Z-48
(2014)

ZONING PLAN FOR:
DAVID PEARSON COMMUNITIES
PROPERTY IS LOCATED IN LAND LOT 629 & 630
IN THE 16TH DISTRICT, 2ND SECTION
COBB COUNTY, GEORGIA
SCALE: 1" = 50'
DATE: APRIL 21, 2014
REVISED: JULY 24, 2014

ZONING COMMENTS:

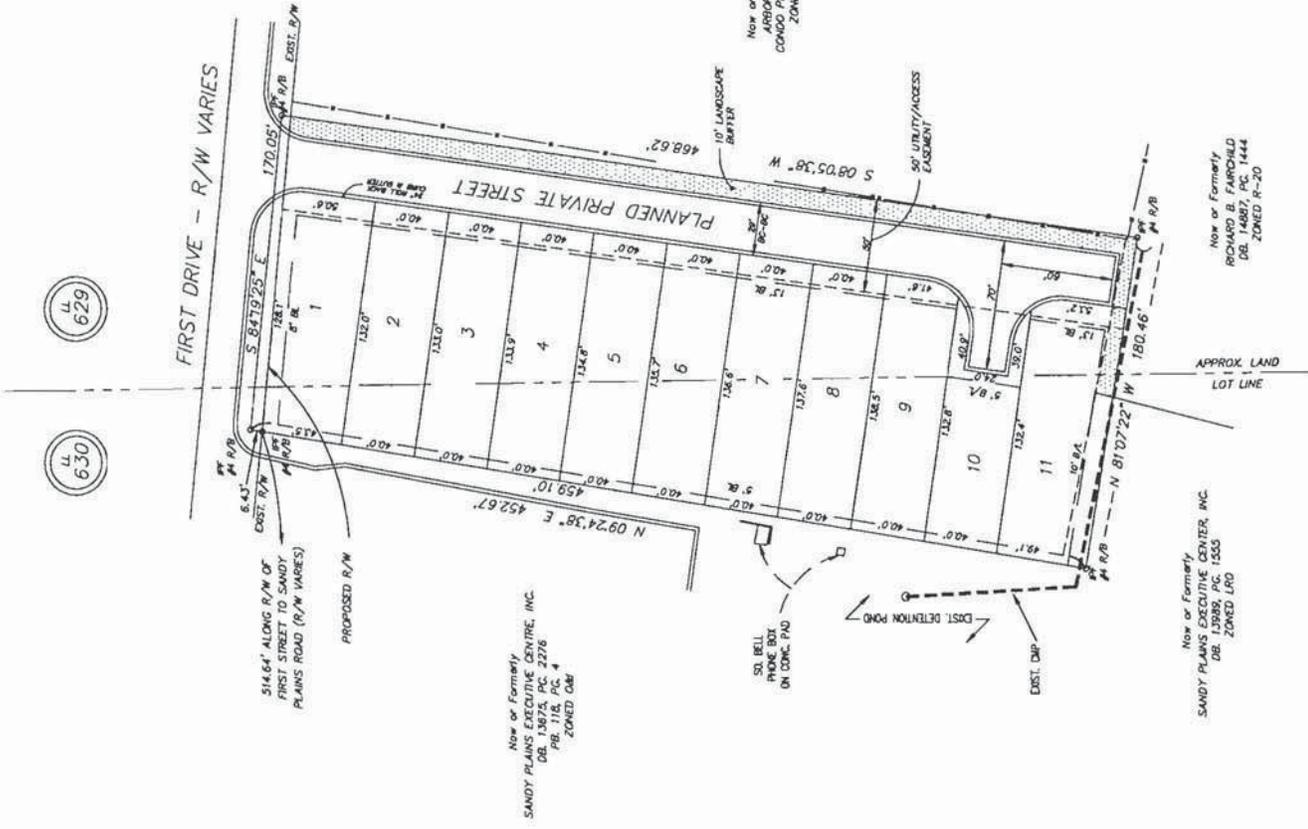
The site plan indicates a private street is planned and the applicant requests that the setbacks for the development be geared toward the private street, instead of First Drive. This will require granting a waiver of the front setback along the private street from 25 feet to 13 feet; waiving the rear setback abutting the eastern property line from 35 feet to 20 feet.

When projects contemplate less than 20 foot separation between units, guest parking shall be provided or the streets shall be labeled as a fire lane.

Additional Comments: Master meter to be set at public ROW

Additional Sewer to be private in private street
Comments:

- No Stormwater controls shown _____
- Copy of survey is not current – Additional comments may be forthcoming when current site conditions are exposed.
- No site improvements showing on exhibit.

1. This site is located on First Drive between Sandy Plains Executive Center to the west and the Arbor Oaks Suburban Condominium development to the east. The entire site drains to the east through the Arbor Oaks development. With the proposed layout a drainage easement will be required along the rear of all the lots to adequately control runoff from the site. Since it appears that underground detention will be utilized under the private street, it may be necessary to relocate the street to the low-side of the site, adjacent to Arbor Oaks, to adequately control site runoff.

2. The detention pond for the adjacent Sandy Plains Executive Center discharges through an existing pipe along the southern boundary of this site. An adequate drainage easement must be provided for this conveyance.
